TALLIL MILITARY BASE  
CAMP UR  
NASIRIYAH, IRAQ

SUSTAINMENT ASSESSMENT

**SIGIR PA-06-087**  
**SIGIR PA-06-088**  
**APRIL 25, 2007**

SUBJECT: Report on Tallil Military Base (Camp Ur) Sustainment, Nasiriyah, Iraq  
(Report Numbers SIGIR PA-06-087 and PA-06-088)

**Site Photo 4. Dislodged shower floor pan at inspection**

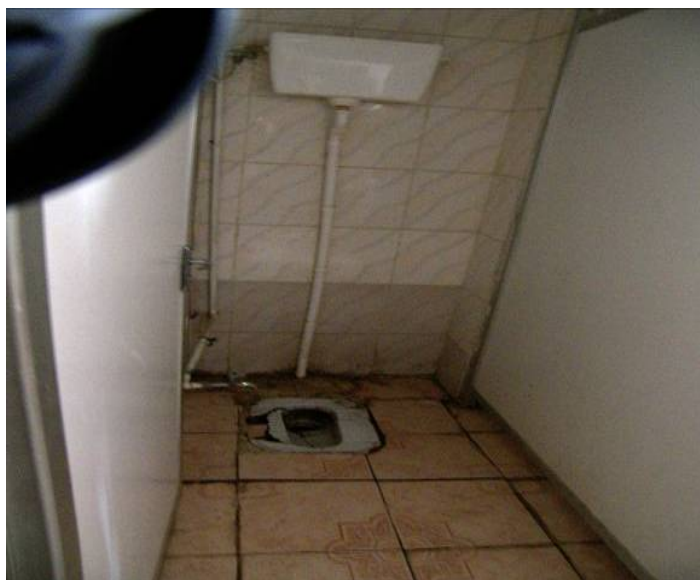
The contract required one shower, sink and toilet for every ten soldiers. The ground floor design met the contract requirements; however, the contractor installed only five of the eight sinks required by the building design for the two barracks SIGIR inspected. The upstairs design provided for enough showers; however its provision for eight sinks and seven toilets to accommodate eighty-four soldiers was short by one sink and two toilets. Furthermore, the contractor installed only five sinks, which increased the shortage to four sinks. Although time limitations prevented the review of all barracks, their similarity in design and construction would indicate similar shortages exist in all enlisted and transient barracks.

The shortage problem was compounded by using plumbing and fixtures that are closer to household grade than commercial grade. The fixtures, supply lines and valves were flimsy and easily broken after being exposed to the volume of use. Floor tile was installed over a sand base and not adequately sealed. Water seeped through the joints causing tile breakage and damage to the ceiling on the ground level. These problems were also identified during the warranty period where seven of thirty-two work requests involved repairs to bathrooms. Also, during a February 2006 site inspection an AFCEE representative noted eighteen warranty items associated with bathroom floors and fixtures.

Inadequate maintenance and apparent abuse by the occupants further compounded the problem. Un-repaired water leaks damaged floors and ground floor ceilings. Broken fixtures left sinks, showers and toilets unusable. Abusive use such as standing on western toilet seats, slamming shower doors, and stuffing water bottles down toilet drains damaged plumbing and fixtures. These abuses were also noted in an AFCEE representative's site visit report dated 2 February 2006 which cited eighteen examples of soldier abuse to the bathrooms including drains filled with debris, discarded drain covers and cracked toilets. The report commented that the abuse started when the Iraqi soldiers occupied the facility. Site Photos 1 through 7 show the damage to the facilities SIGIR inspected.

1. Although MNSTC-I should insure the barracks' bathrooms have the required compliment of commercial grade sinks, toilets, and showers, undertaking significant corrective action without insuring the facilities will be properly maintained would not be cost effective. Therefore, MNSTC-I should consider delaying corrective action until Operations and Maintenance (O&M) demands are met. MNSTC-I should also determine if the broken air conditioners are warranty issues that should be repaired by the contractor.
